PRODUCT BULLETIN 36138

Predator Front Frame Lifting Modification

Date: 08-06-2022

Revision: A

Figure 1: Front Frame Fatigue Life Improvement

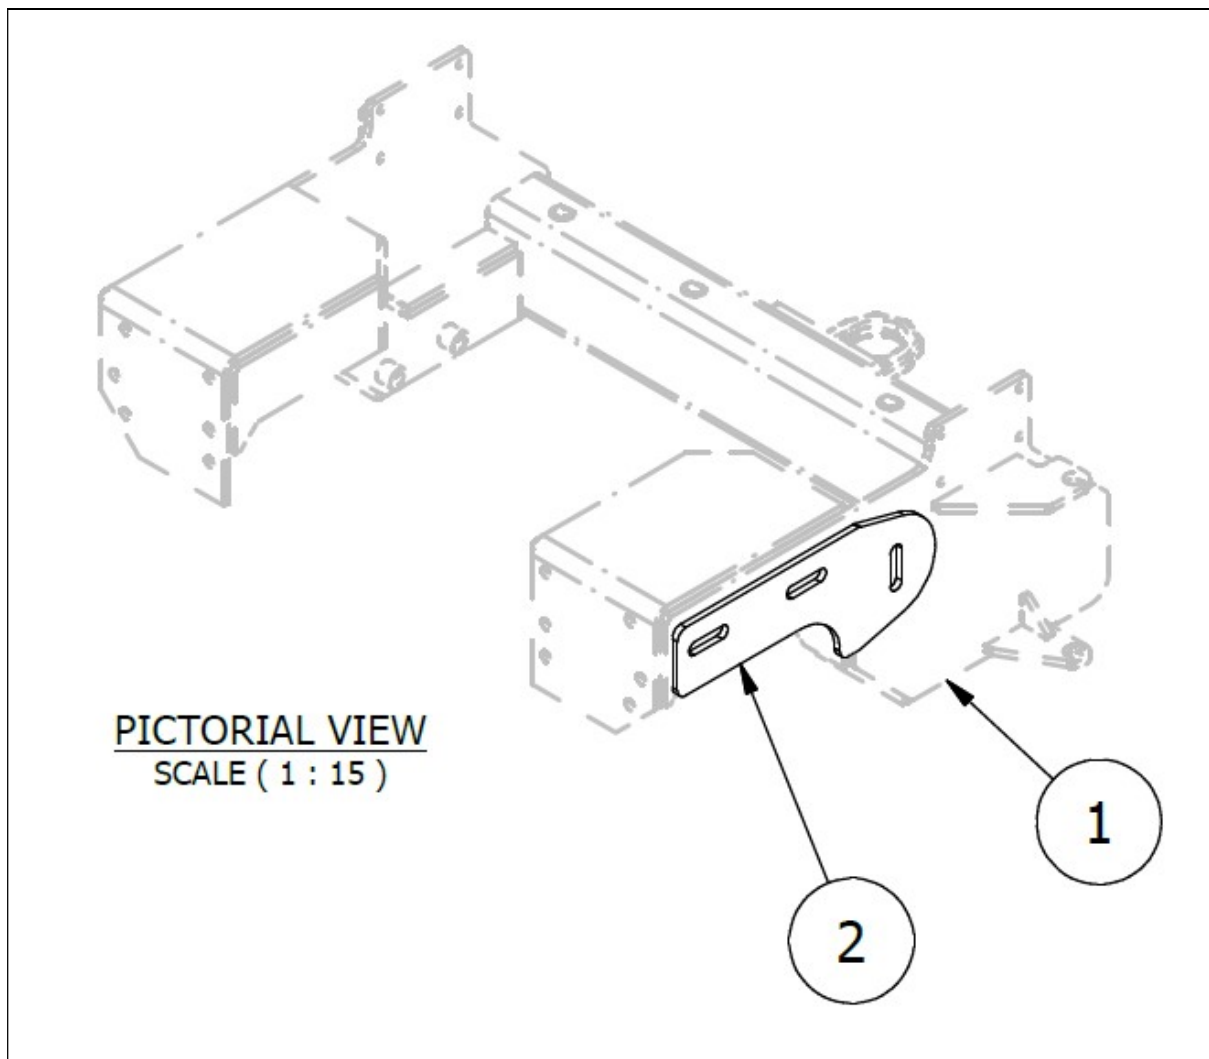
The load factors of the front chassis frame have been reviewed for the load case of lifting the front of the vehicle onto stands. After detailed analysis, it has been established there may be a fatigue concern in the main side plates of the front frame, when subjected to ongoing lifting and lowering. No incidents or fatigue cracking have yet been observed or reported in the front frame.

To address concerns with potential fatigue cracking in the future, a strengthening doubler plate design has been developed and analysed as shown in **Figure 1**. The addition of the doubler plate reduces bending stress by approximately 40%

- Implement ongoing inspection on predator front frames if not already in the mines maintenance schedule
- Where the machine is lifted onto stands via the front frame, make arrangements with Cougar Mining Equipment for installation of doubler plate addition as per the depiction in figure 1. A lifting procedure for performing this task is also available from CME.

Figure 2: Front Frame Area of Concern

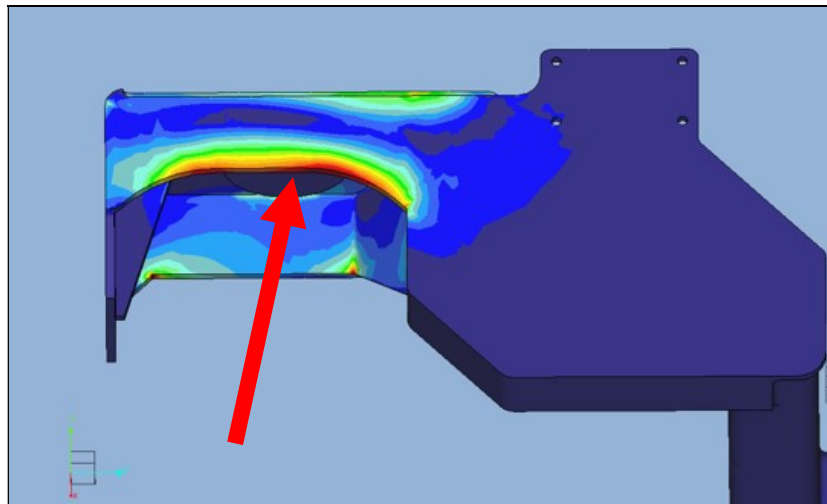
Cougar Mining Equipment recommend weekly visual inspection of the front frame and chassis rails with magnetic particle inspection to be performed on lift points on an annual basis, and the entire frame on a maximum of 4 yearly basis. Particular attention should be paid to the underside of the front frame side plate in the vicinity of the front axle as indicated in **Figure 2**.

Figure 3: Depth of section increase for all new frames

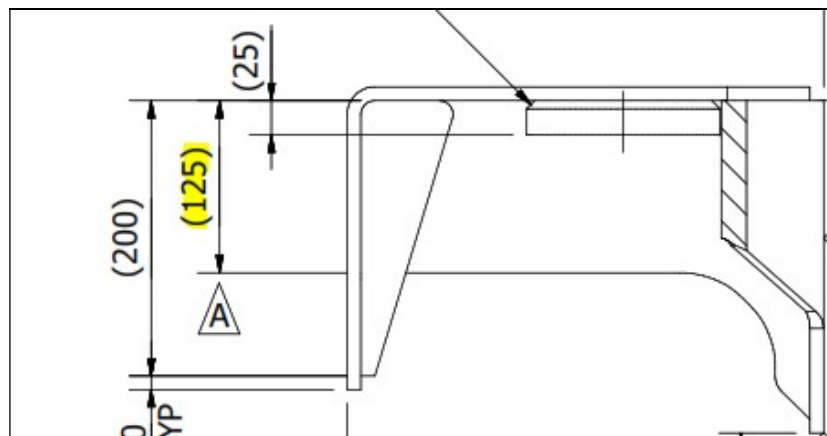
Future releases of the front frame will be installed with an improved side plate design to eliminate the need for the doubler plate. The depth of section of the side plates for future versions is 125mm as indicated in **Figure 3**. Later versions do not require the doubler plate.
